PR/0713/22

Record of Executive Business and Chief Executive's Order

Reg. Reference: SDZ22A/0006 **Application Date:** 13-Apr-2022
Submission Type: New Application **Registration Date:** 13-Apr-2022

Proposed Development: Construction of 352 residential units (terraced, semi-detached and detached) comprising 253 two storey houses (15 two bed units and 238 three bed units ranging in size from c. 86sq.m to c. 118sq.m) and 99 three storey houses (18 three bed units and 81 four bed units and ranging in size from c. 147sq.m to c. 189sq.m); The total gross floor area of the development is c. 43,272sq.m; The development will also comprise the provision of 2 vehicular accesses from Adamstown Boulevard, 1 vehicular access from Adamstown Drive (L1030), 2 vehicular accesses from Adamstown Park Road and 2 vehicular accesses from Tandy's Lane; vehicular connections will also be provided to permitted roads in Tandy's Lane Phase 1; internal routes; 535 car parking spaces including on-curtilage and off-curtilage spaces; bicycle parking; bin storage; plant; ESB Substations; boundary treatments; lighting; hard and soft landscaping; and all other associated site works; on 2 No. sites separated by th

Figure 8 parking on a bend

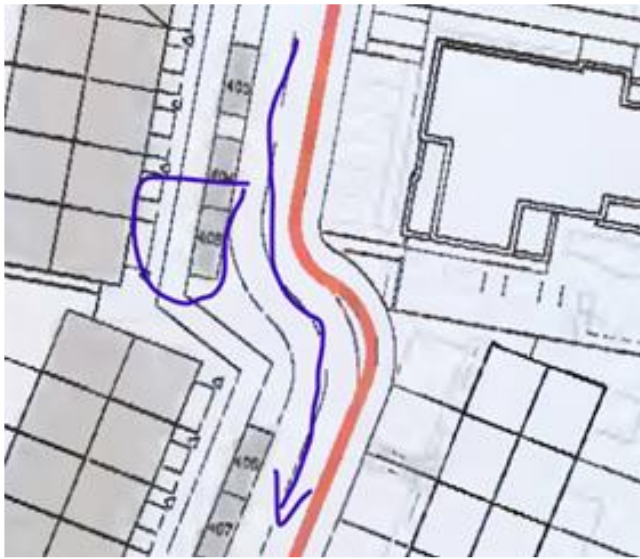
The TII have recommended a road safety audit to identify the roads issues within the development, SDCC roads department concur.

- 1. The applicant is to submit a revised plan layout showing all homezones with perpendicular parking having a turning length of 6.0m behind the parking spaces for safe access and egress from the parking bays.*

Figure 9 how are these space on curtilage.

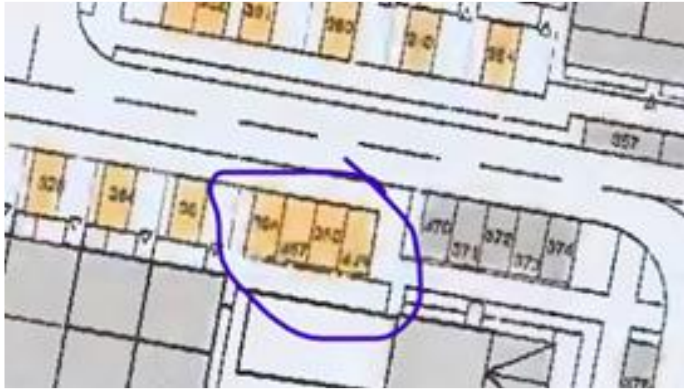
The parking spaces identified in Figure 9 are shown as in curtilage, it is not clear if these spaces will be in the public domain or not and could result in confusion regarding private parking spaces and public off curtilage spaces that have been taken in charge. policy 2.4.22 of the Adamstown SDZ “no more 60% offer residential car parking spaces shall be provided as private In-Curtilage parking spaces in any development area. “

- 5. The applicant is to submit details of a the in-curtilage parking spaces to be within the boundary of private areas.*
- 6. The applicant is to submit details of a roads layout that matches the layout as proposed in the SDZ area masterplan.*
